IEEE P802.15
Wireless Personal Area Networks

Project	IEEE P802.15 Working Group for Wireless Personal Area Networks (WPANs)	
Title	TG3 D10 running comment resolutions	
Date Submitted	[8 July, 2002]	
Source	[James P. K. Gilb] [Appairant Technologies] [9921 Carmel Mountain Rd. #247, San Diego, CA 92129]	Voice: [858-538-3903] Fax: [858-538-3903] E-mail: [gilb@ieee.org]
Re:	[]	
Abstract	[This document is a record of comment resolutions for LB17.]	
Purpose	[To provide a record of the comment resolution for LB17.]	
Notice	This document has been prepared to assist the IEEE P802.15. It is offered as a basis for discussion and is not binding on the contributing individual(s) or organization(s). The material in this document is subject to change in form and content after further study. The contributor(s) reserve(s) the right to add, amend or withdraw material contained herein.	
Release	The contributor acknowledges and accepts that this contribution becomes the property of IEEE and may be made publicly available by P802.15.

2. Comment resolution in Schaumburg

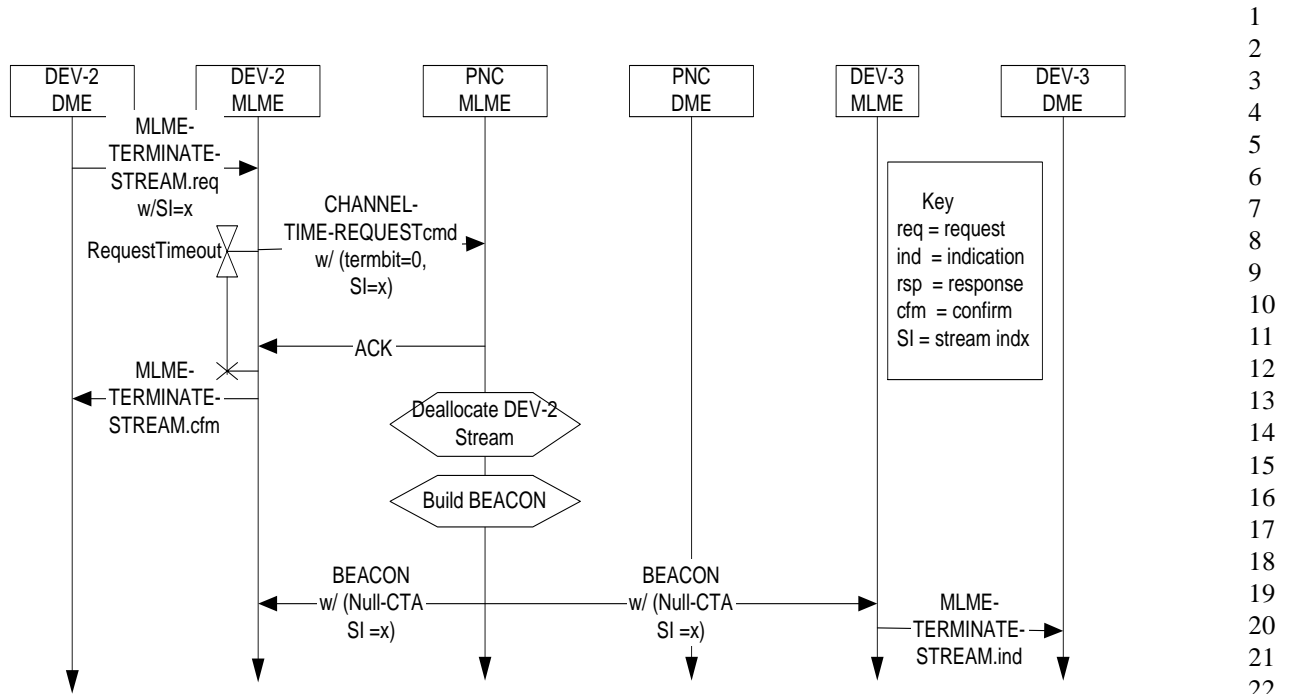
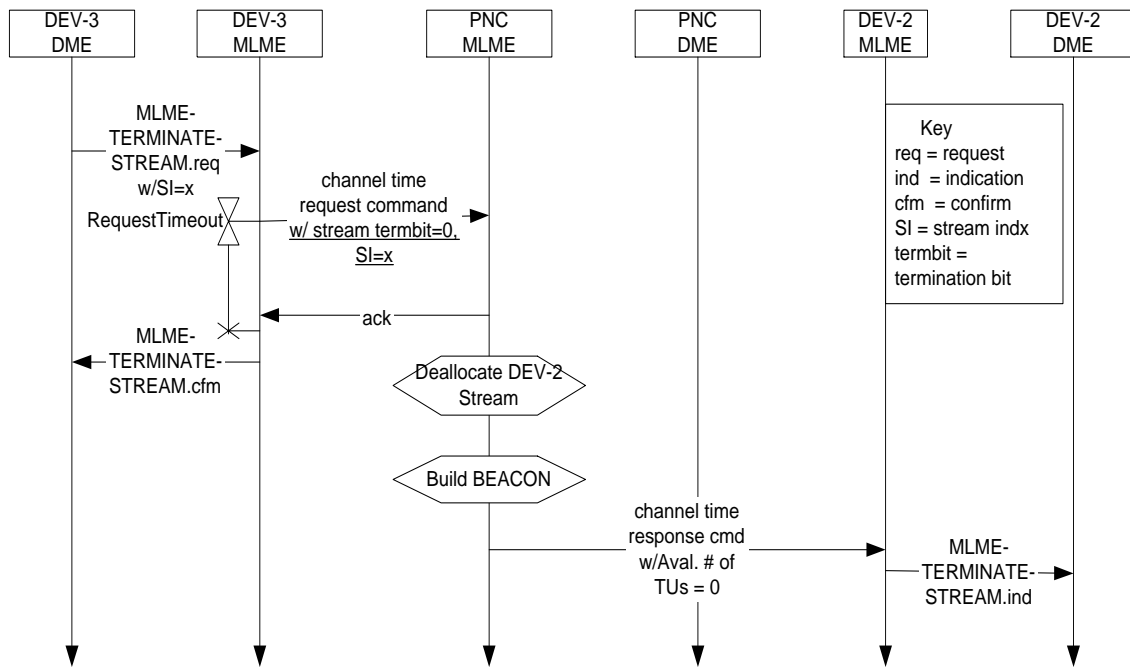
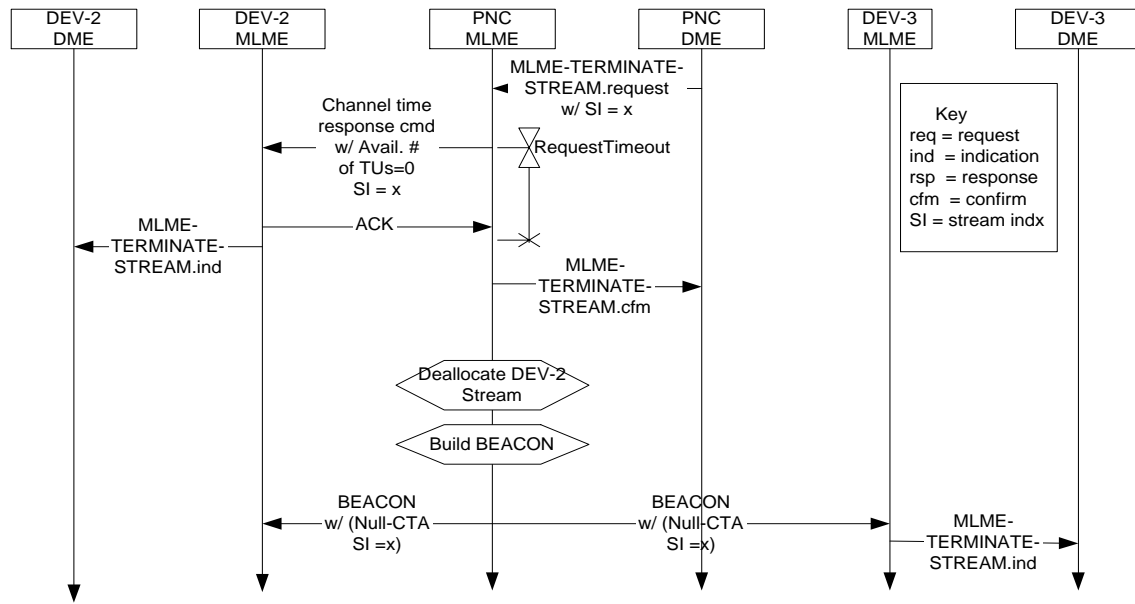
907 (Bain,TR) Grammatical errors and reference to figure 118 is incorrect and does not pertain to text in this section. Consequently, change the paragraph to the following: "In the case where the PNC wishes to terminate the stream, it shall notify the originating DEV and the target DEV via the next periodic beacon that the CTAs assigned to the indicated stream index are set to a null CTA value for aMinBeaconInfoRepeat duration." **Suggest reject** pending acceptance of CID 364

155 (Heberling, TR) KO> MLME-TERMINATE-STREAM.indication not used for target, only source. Consequently, for clause 6.3.14.10 MLME_TERMINATION_CTA.indication <change from> This primitive is used to inform the target DEV that channel time that was previously allocated is no longer present in the most recently received beacon. <to> This primitive is used to inform the source DEV that channel time that was previously allocated is no longer present in the most recently received beacon. **Suggest accept in principle**, “Change 6.3.14.10 as indicated in 02/273r12”

Resolution is to reject, "Figure 118 has been removed, a new termination procedure in 02/273r13 describes with correct MSCs the procedure."

The PNC, upon receiving a channel time request command from a DEV requesting stream termination, shall respond with an ACK. In the case where the stream originating DEV is requesting a stream termination, the PNC shall then notify the target DEV of the termination via a null CTA in the beacon for {xref aMinBeaconInfoRepeat} duration. For CTAs that were not allocated every beacon, e.g. subrate slots, the null CTAs shall be placed starting in the beacon where the next CTA would have occurred and in the following {xref aMinBeaconInfoRepeat}-1 beacons. A null CTA has the stream index, SrcID and DestID with zero values for the slot location and slot duration, {xref 7.4.8}. {xref Figure 16} illustrates the MSC for termination of a stream by a source DEV. In the case where the target DEV is requesting a stream termination, the PNC shall then notify the stream originating DEV of the termination via a channel time response command. {xref Figure 17} illustrates the MSC for termination of a stream by a target DEV.

In the case where the PNC decides to terminate a stream originating DEV's stream, the PNC shall notify the source DEV via a channel time response command and the target DEV via a null CTA in the beacon for aMinBeaconInfoRepeat duration. For CTAs that were not allocated every beacon, e.g. subrate slots, the null CTAs shall be placed starting in the beacon where the next CTA would have occurred and in the following {xref aMinBeaconInfoRepeat}-1 beacons. {xref Figure 18} illustrates the termination of a source DEV's stream by the PNC.

Figure 21—MSC for the initiating of a neighbor piconet.

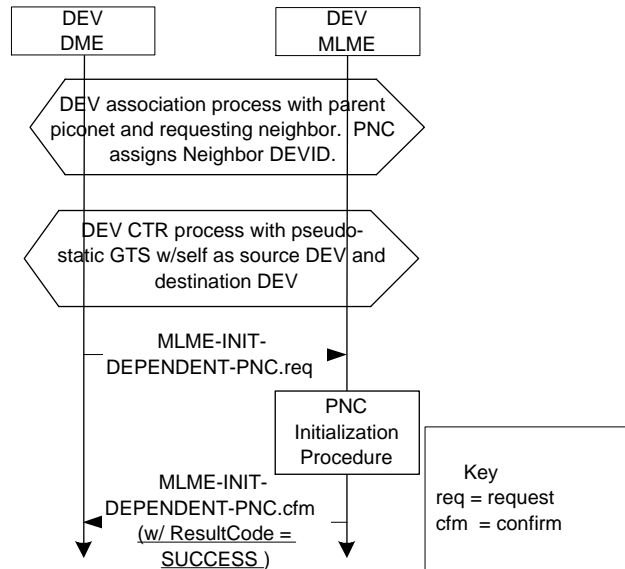
179 (Heberling, TR) - Figure 98 should be replaced with a proper MSC of the required protocol needed to establish a neighbor piconet. Replace figure 98 with a proper MSC. **Suggest accept** - An MSC for neighbor piconet initialization is included below. It needs twiddling to get the vertical lines to not show in the hex pro-

cess blocks. Also, although consistent with other similar diagrams, this MSC seems to need the first beacon of the neighbor PNC shown.

Accept in principle, “Accept suggested resolution but add a line at the bottom that shows the first beacon being sent. Also add after the sentence that says ‘The MSC for the initiation a neighbor piconet is illustrated in Figure 21.’ the following sentence, ‘The association and channel time request processes are defined in xref and xref, respectively.’”

Figure 22—MSC for the creating a child piconet.

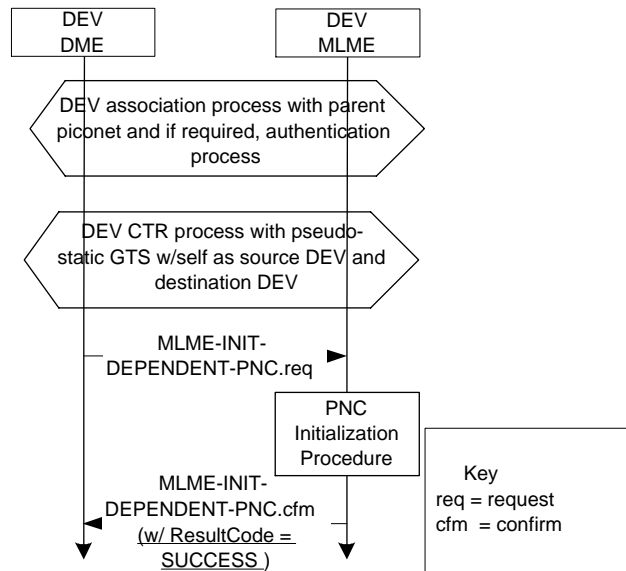
177 (Heberling, TR) - Figure 96 should be replaced with a proper MSC of the required protocol needed to establish a child piconet. Replace figure 96 with a proper MSC. **Suggest accept** 'An MSC for child piconet initialization is included below. It needs twiddling to get the vertical lines to not show in the hex process blocks. Also, although consistent with other similar diagrams, this MSC seems to need the first beacon of the child PNC shown.

Accept suggested resolution but add a line at the bottom that shows the first beacon being sent. Also add after the sentence that says 'The MSC for creating a child piconet is illustrated in Figure 22.' the following sentence, 'The association and channel time request processes are defined in xref and xref, respectively.'

Figure 23—MSC for a approved asynchronous channel time request

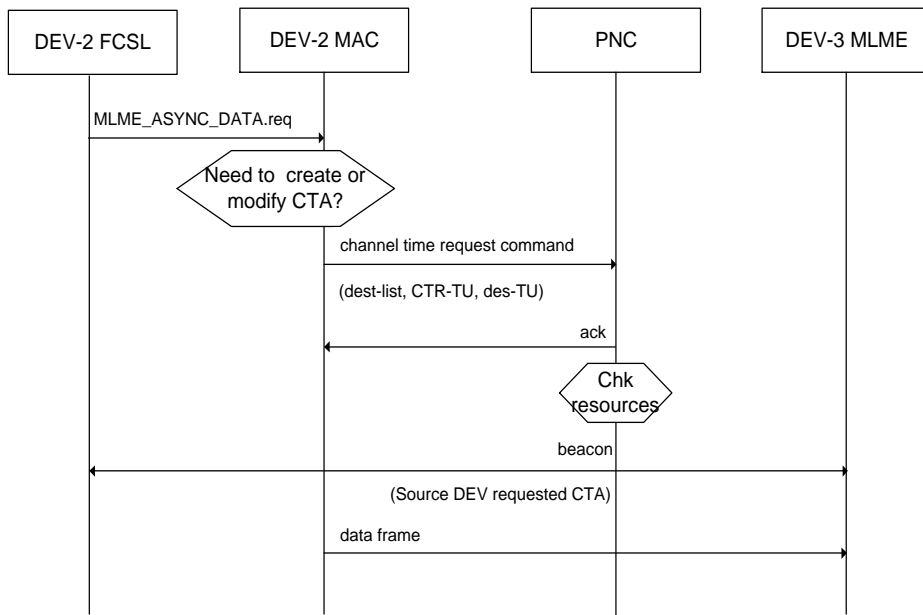
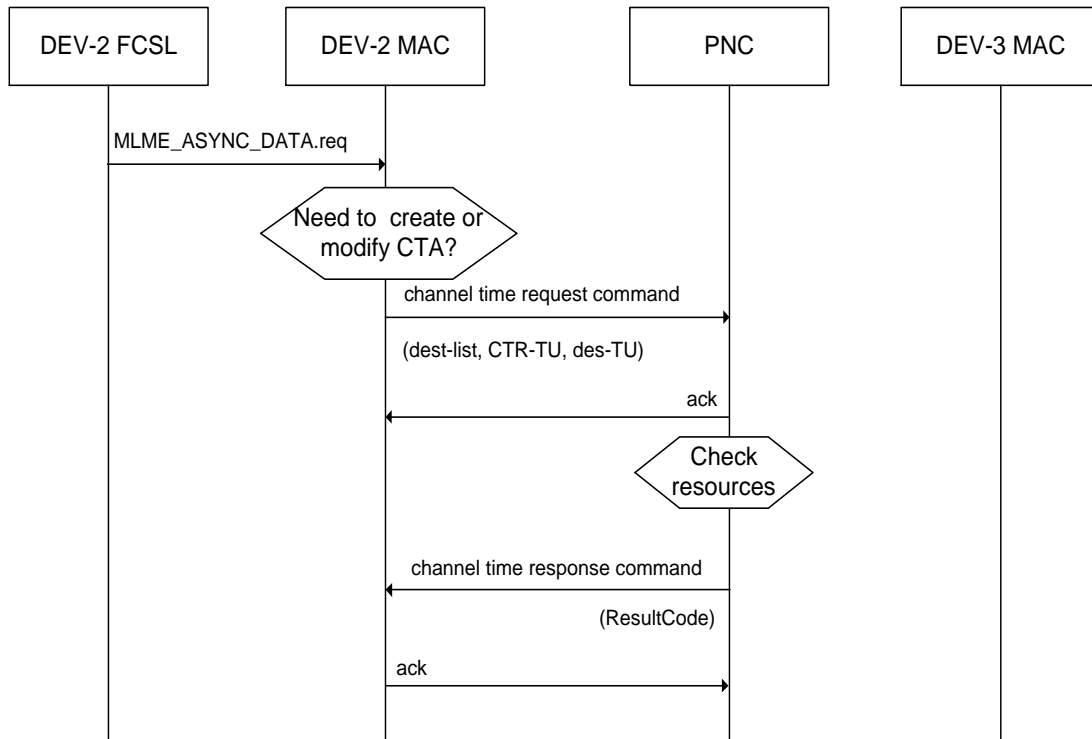
327 (Heberling, TR) Figure 119 is a flawed MSC of the Asynchronous channel time reservation process and data frame exchange. Consequently, delete the current MSC from this section of clause 8.5.2.1 and replace it with 02r0P802-15_TG3-Asynch-channel-time-allocation.eps. **Suggest accept.**

<Page 182, Figure 119> – MSC for reserving asynchronous data channel time. Discussed earlier, new MSC is below (needs work to match the other MSCs in the clause.):
